Addendum mumber 01	00 9113
Food & Nutrition Services		
Lost Mountain Middle School: Cooler and Freezer Replacement	t	202014
Hayes Elementary School: Cooler and Freezer Replacement		202015
Mount Bethel Elementary School: Freezer Replacement, HVAC		202016
System, Kitchen Hood and UDS		
	Delease Date	Cobruger 0 2021

Addondum Number 01

Projects: Lost Mountain Middle School 700 Old Mountain Road Kennesaw, Georgia 30152 CCSD # S5S005LMTM

- Owner: Cobb County School District 514 Glover Street Marietta, Georgia 30060
- Architect: MWL Architecture, LLC 17 Summerfield Crossing Acworth, Georgia 30101

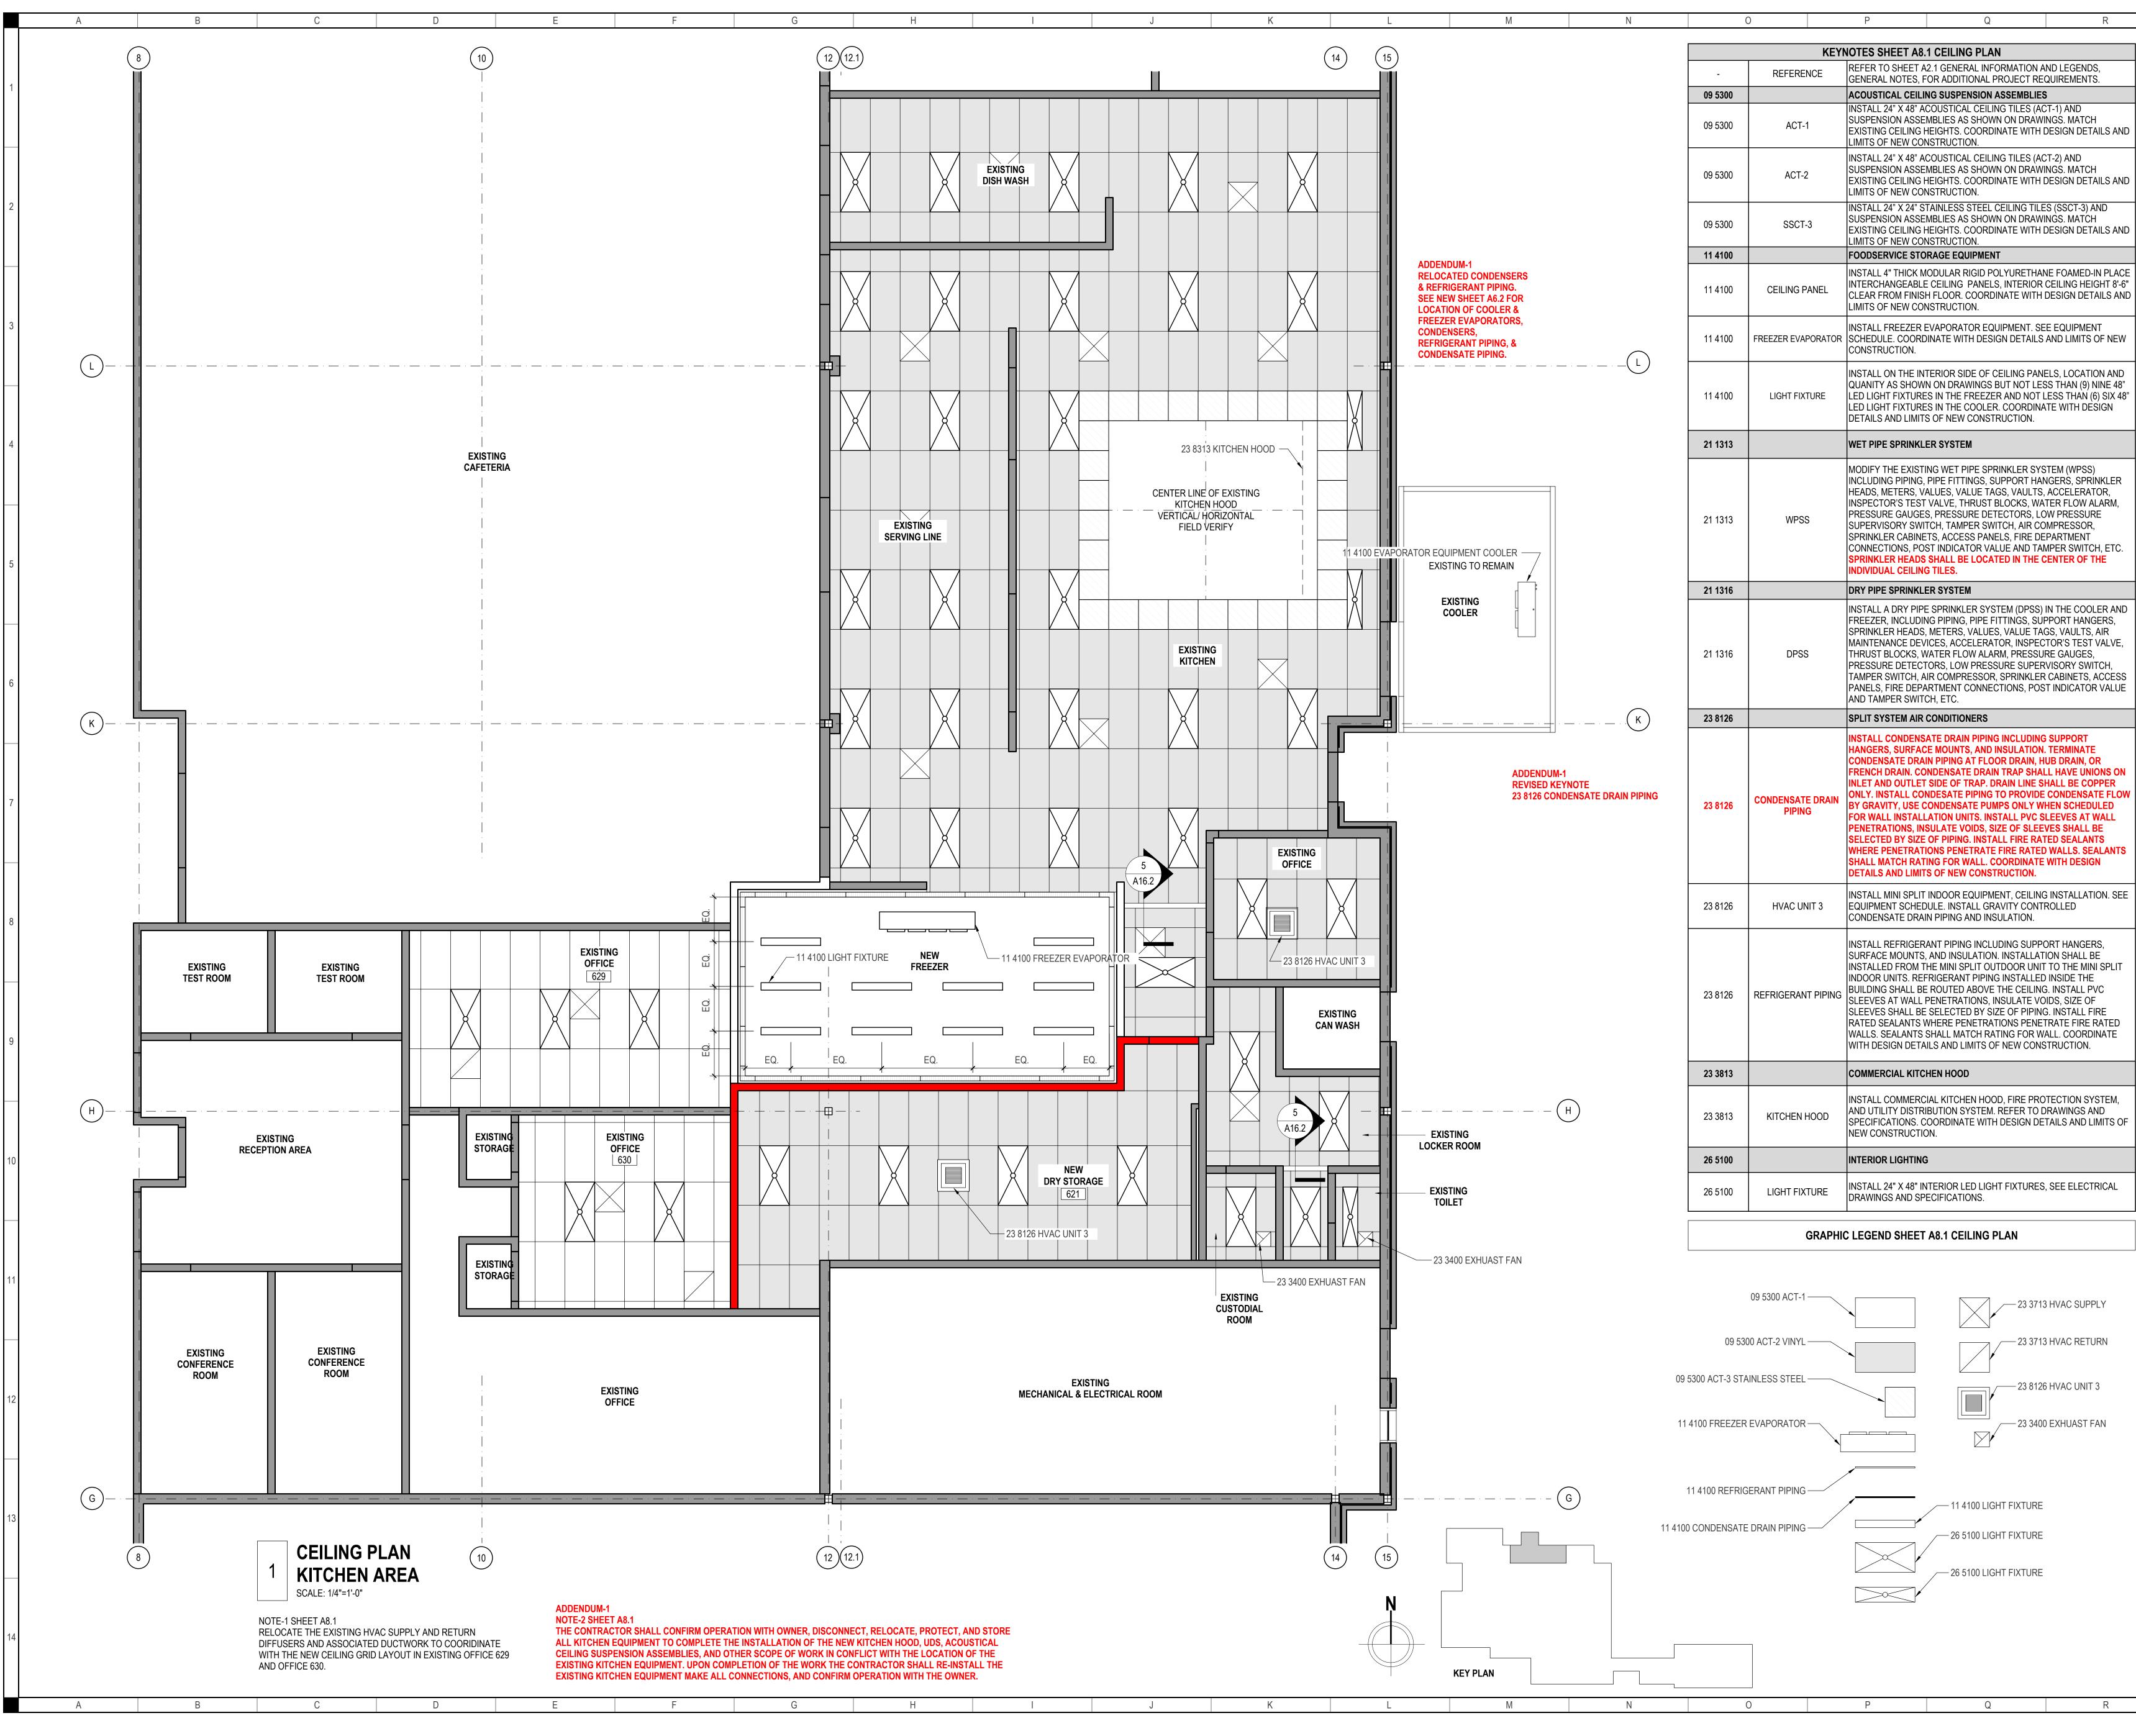
NOTE-1 SHEET A6.2 EQUIPMENT PLAN
